WEST MARGINAL FLOAT REPLACEMENT SELDOVIA, ALASKA

THE FOLLOWING PLAN SET CONTAINS ANNOTATIONS DOCUMENTING CHANGES TO THE PROJECT REPORTED TO HAVE BEEN MADE DURING CONSTRUCTION. THESE MARKUPS ARE BASED REDLINES AND RECORDS PROVIDED BY HARRIS SAND & GRAVEL. ANNOTATIONS PREPARED BY MOFFATT & NICHOL ARE FOR INFORMATION PURPOSES ONLY.

BID SET, 14 FEB 2014
AKV292
P2 NO. 326049

SELDOVIA, ALASKA
WEST MARGINAL FLOAT REPLACEMENT
MECHANICAL
DETAILS
PIPING DETAILS 1

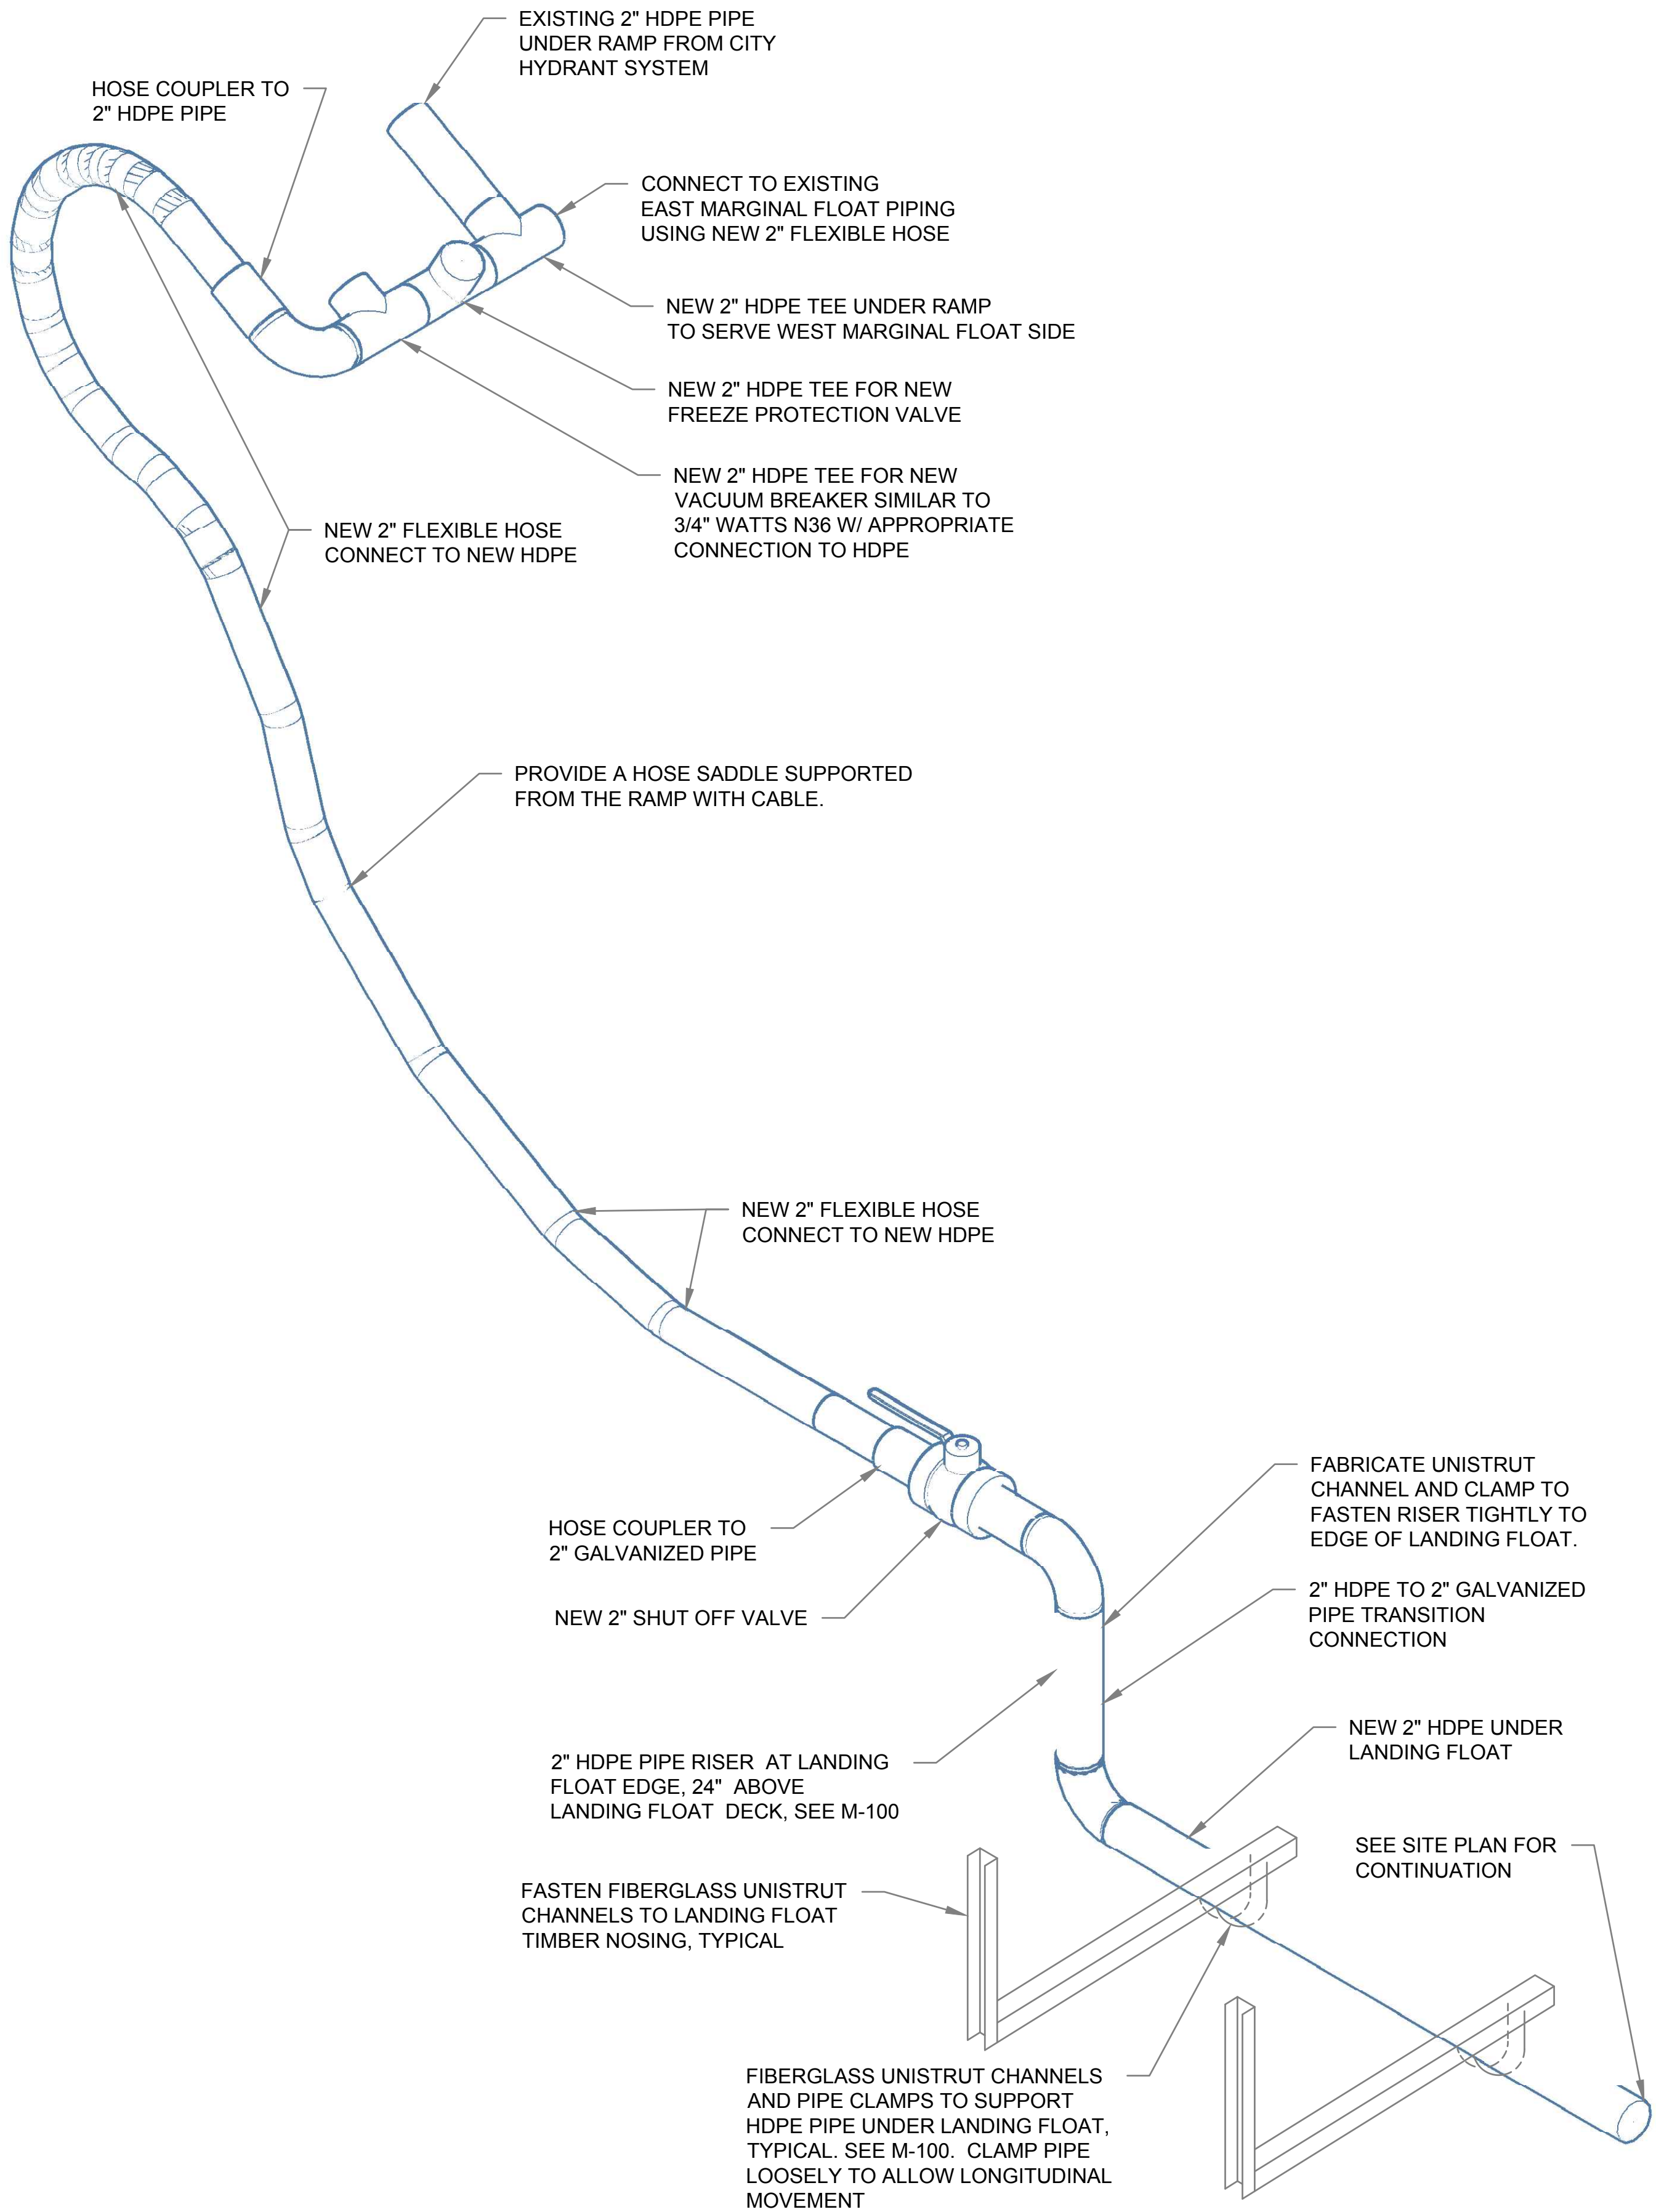
PLUMBING MATERIALS DELIVERED TO CITY OF SELDOVIA BUT WERE NOT INSTALLED AS A PART OF THIS PROJECT.

B NEW HDPE CONNECTION TO EXISTING HDPE PIPING DETAIL
NOT TO SCALE

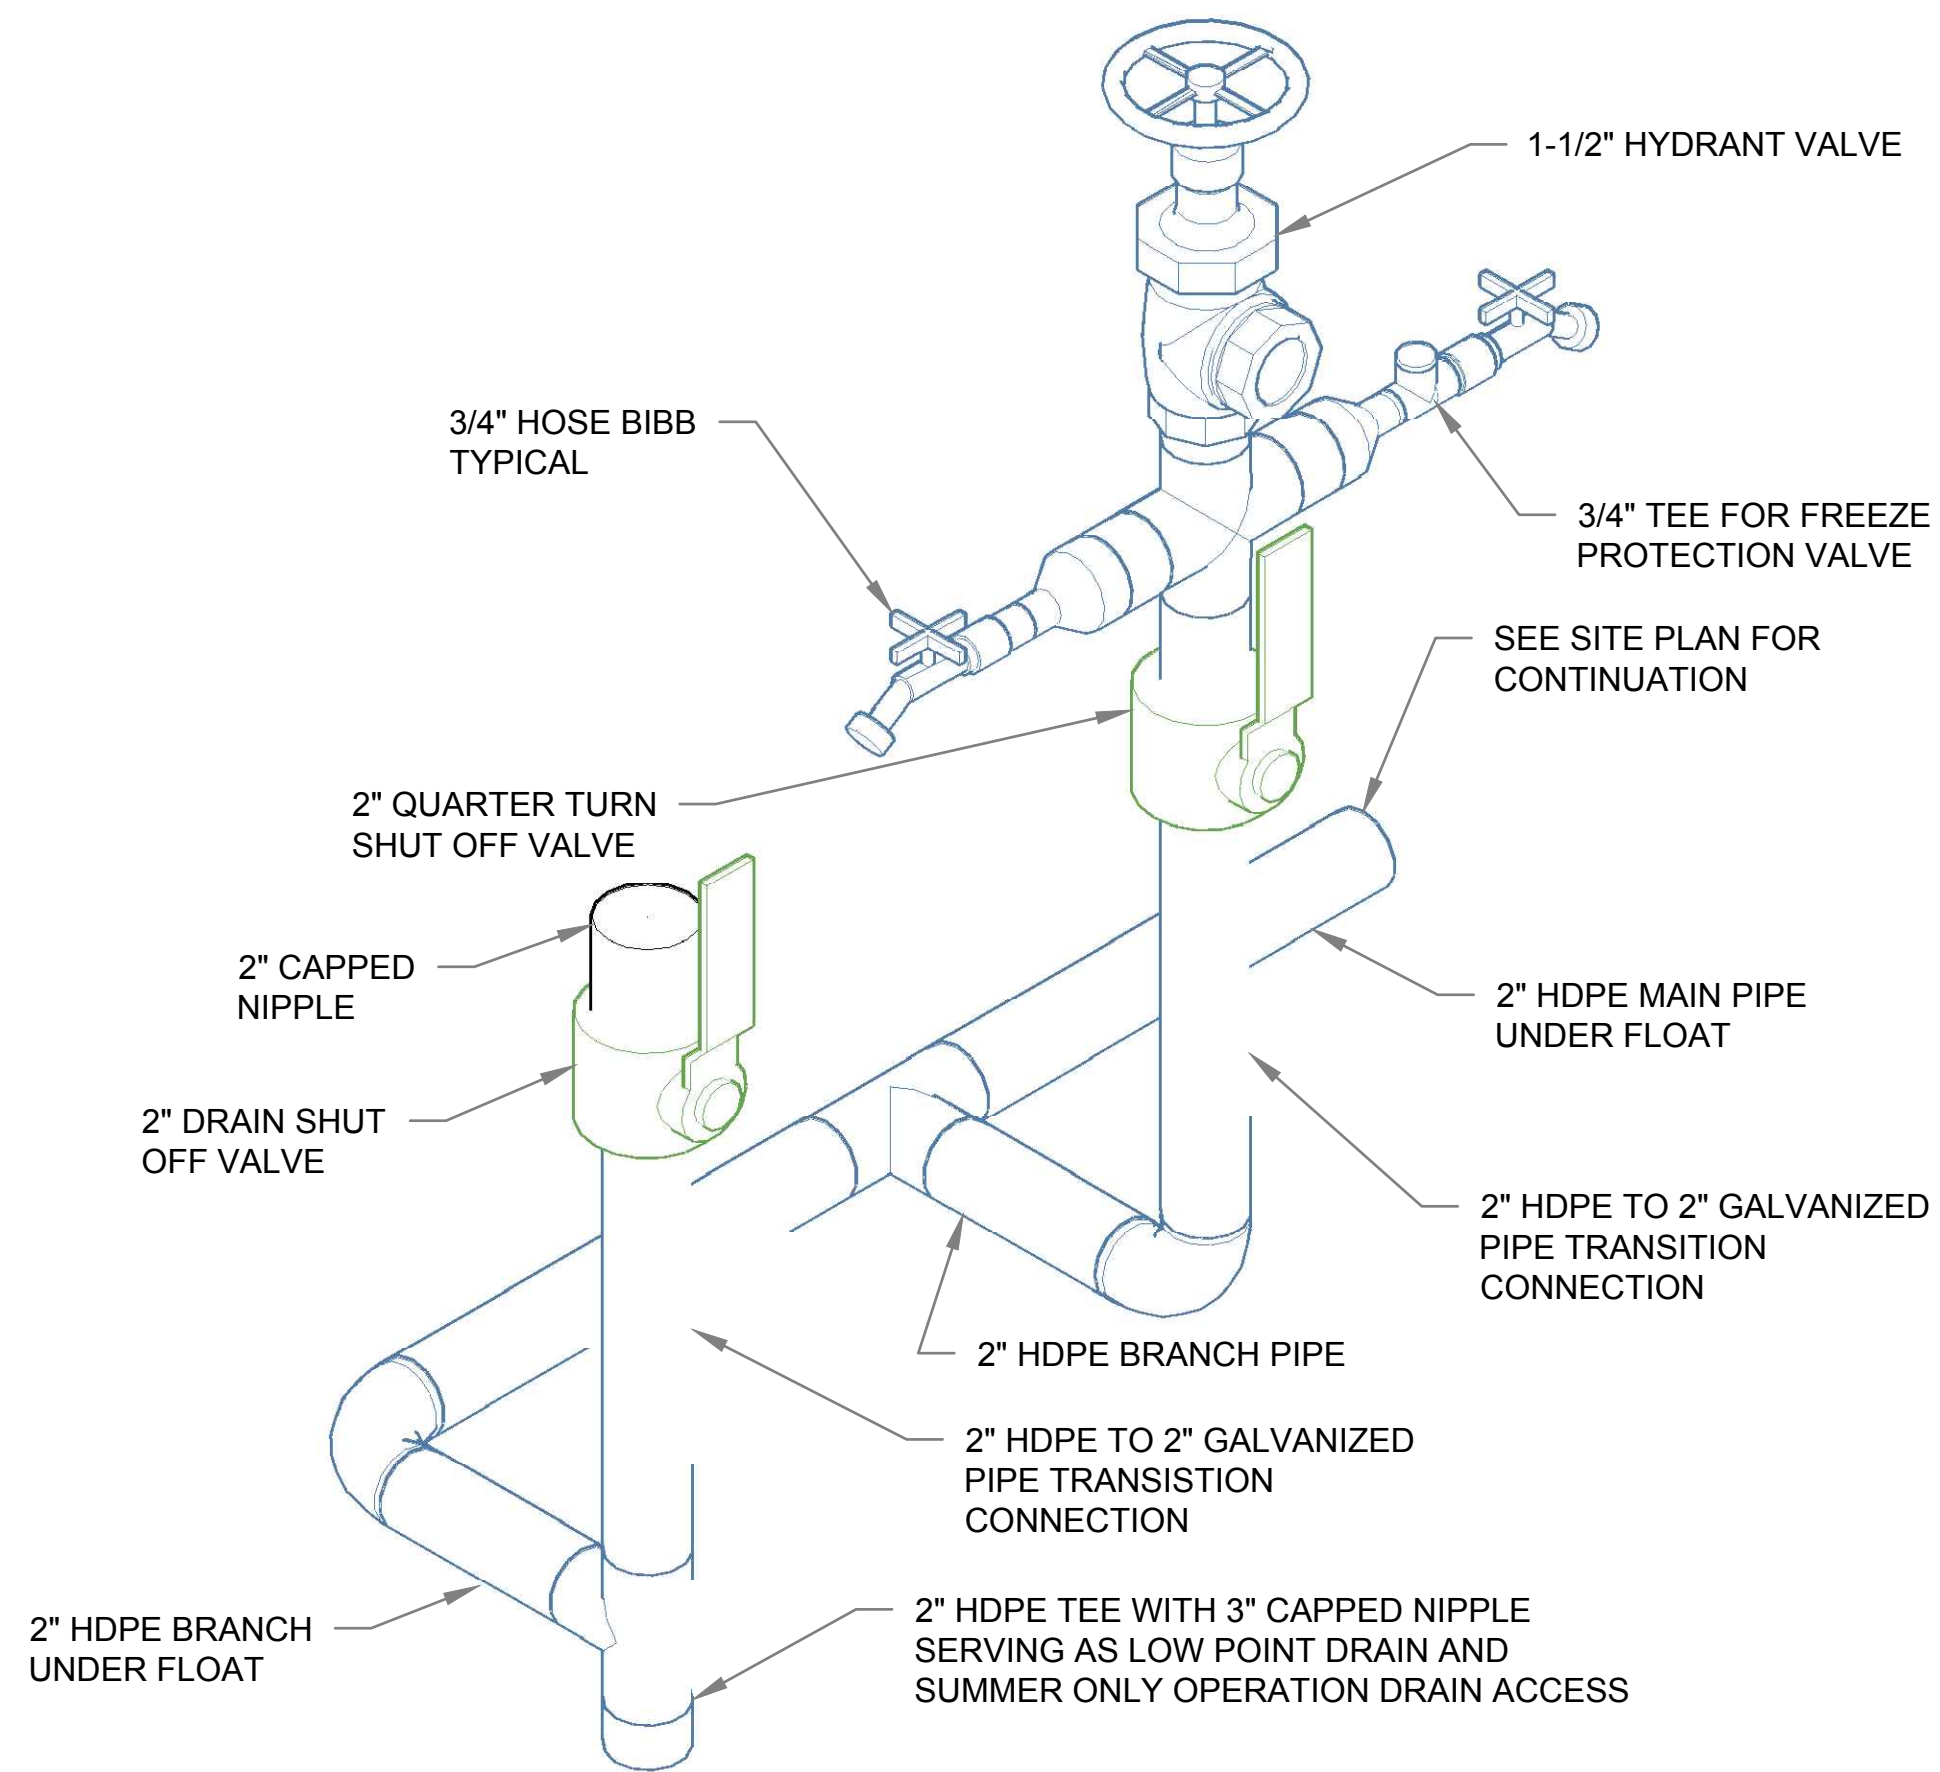
PLUMBING MATERIALS DELIVERED TO CITY OF SELDOVIA BUT WERE NOT INSTALLED AS A PART OF THIS PROJECT.

NEW WORK — DETAIL B

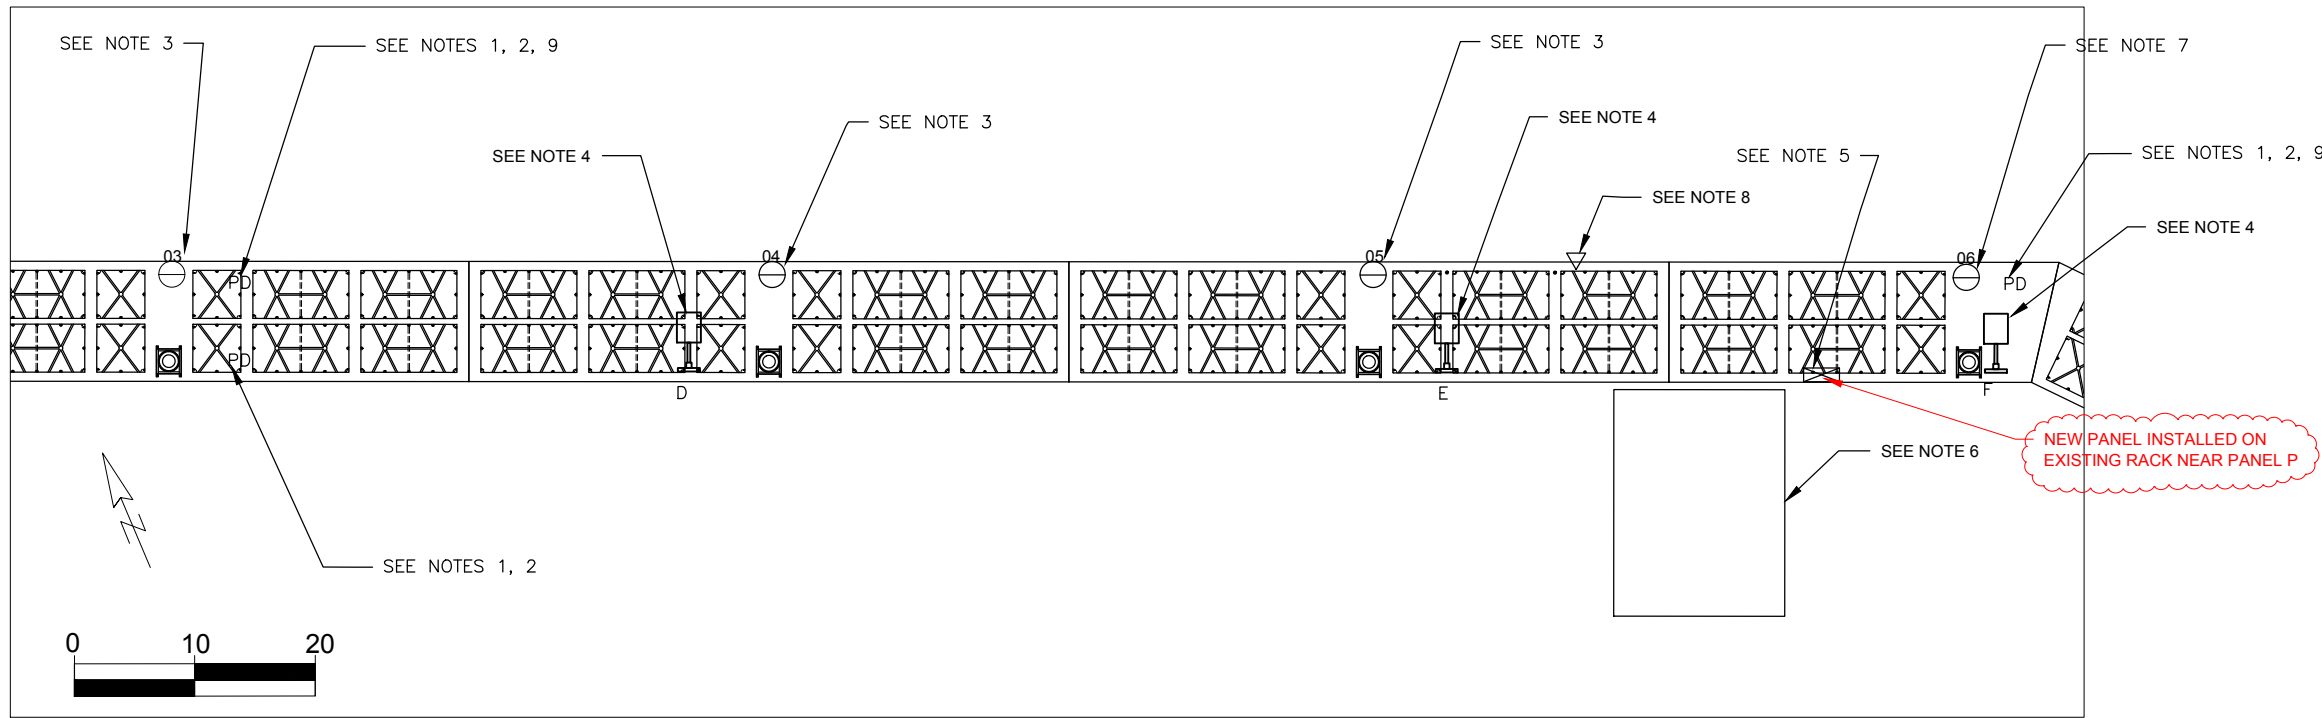
SEE REVISED PANEL SCHEDULE
ON SHEET E-115

7. NEW LIGHT POLE LOCATION CONSISTING OF A 25 FOOT, ~~ROUND-TAPERED POLE~~, A HORIZONTAL BRACKET FOR A 400 WATT METAL HALIDE FIXTURE TYPE A, AND ALL THE REQUIRED HARDWARE FOR A FUNCTIONAL INSTALLATION. PROVIDE A METALLIC LABEL ON POLE WITH POLE LOCATION NAME. PROVIDE GLARE SHIELD AND ANTI-PERCHING MATERIAL ON FIXTURE. FIXTURE SHALL BE AIMED 48 DEGREES FROM HORIZONTAL LEVEL. PROVIDE ALL WIRING AND CONNECTIONS TO THE NEW BRANCH CIRCUITS FROM NEW POWER PANEL Q. TYPICAL ALL NEW SINGLE FIXTURE LIGHT POLE LOCATIONS. SEE SHEET E-112.

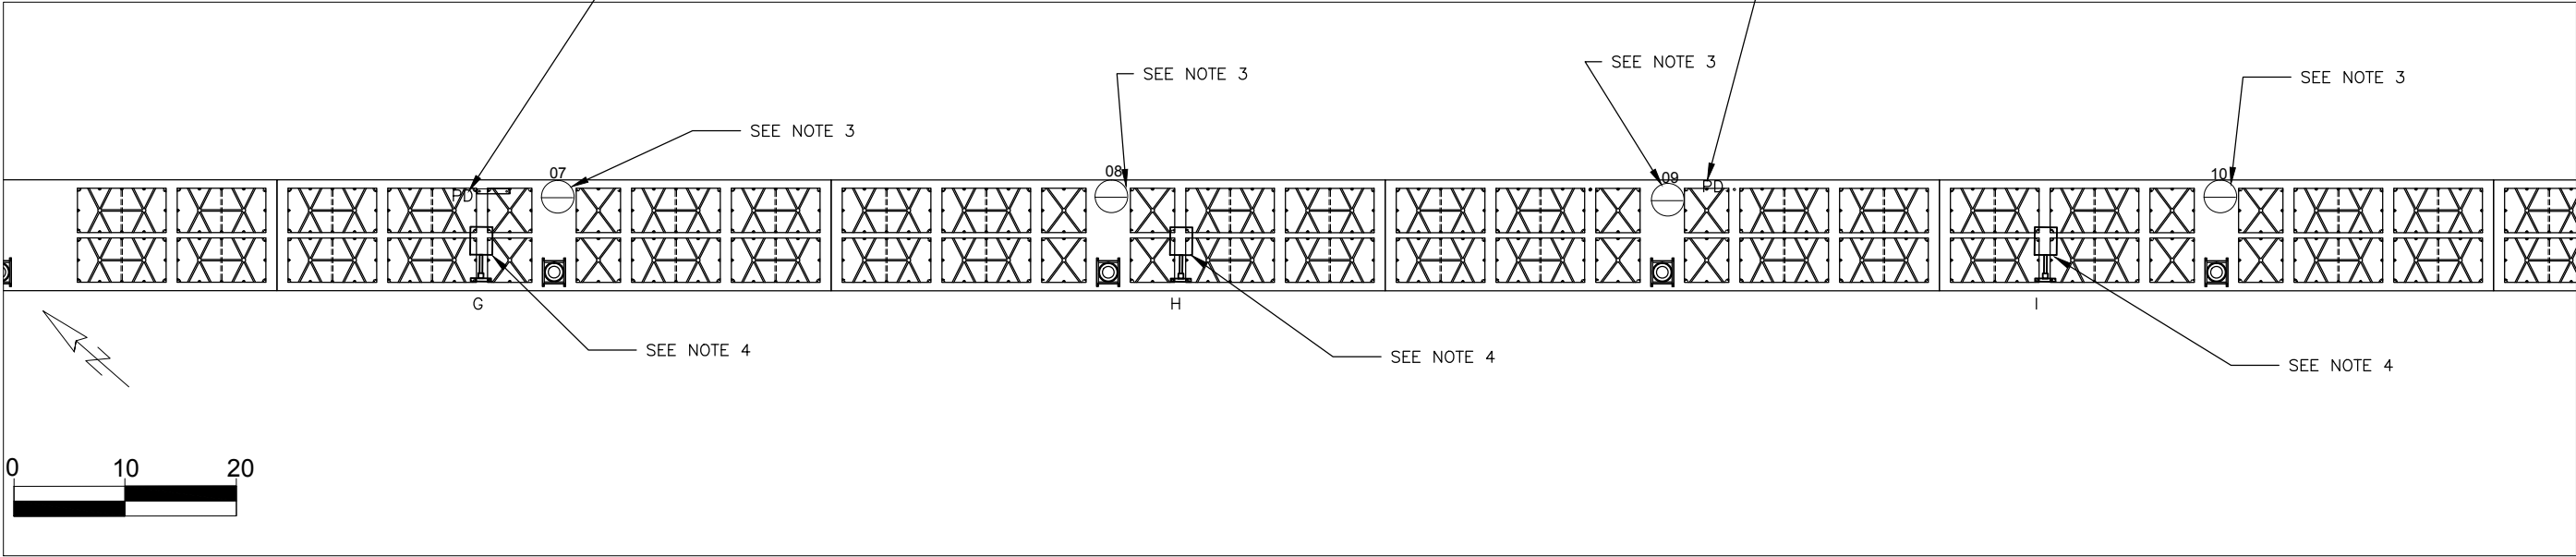
3. NEW FLOODLIGHT LOCATION CONSISTING OF A 25 FOOT, ~~ROUND TAPERED POLE~~, A HORIZONTAL BRACKET FOR A 400 WATT METAL HALIDE FIXTURE TYPE A, AND ALL THE REQUIRED HARDWARE FOR A FUNCTIONAL INSTALLATION. PROVIDE A METALLIC LABEL ON POLE WITH POLE LOCATION NAME. PROVIDE GLARE SHIELD AND ANTI-PERCHING MATERIAL ON EACH FIXTURE. FIXTURE SHALL BE AIMED 48 DEGREES FROM HORIZONTAL LEVEL. PROVIDE ALL WIRING AND CONNECTIONS TO THE NEW BRANCH CIRCUITS FROM NEW POWER PANEL Q. TYPICAL ALL NEW SINGLE FIXTURE LIGHT POLE LOCATIONS. SEE SHEET E-112.
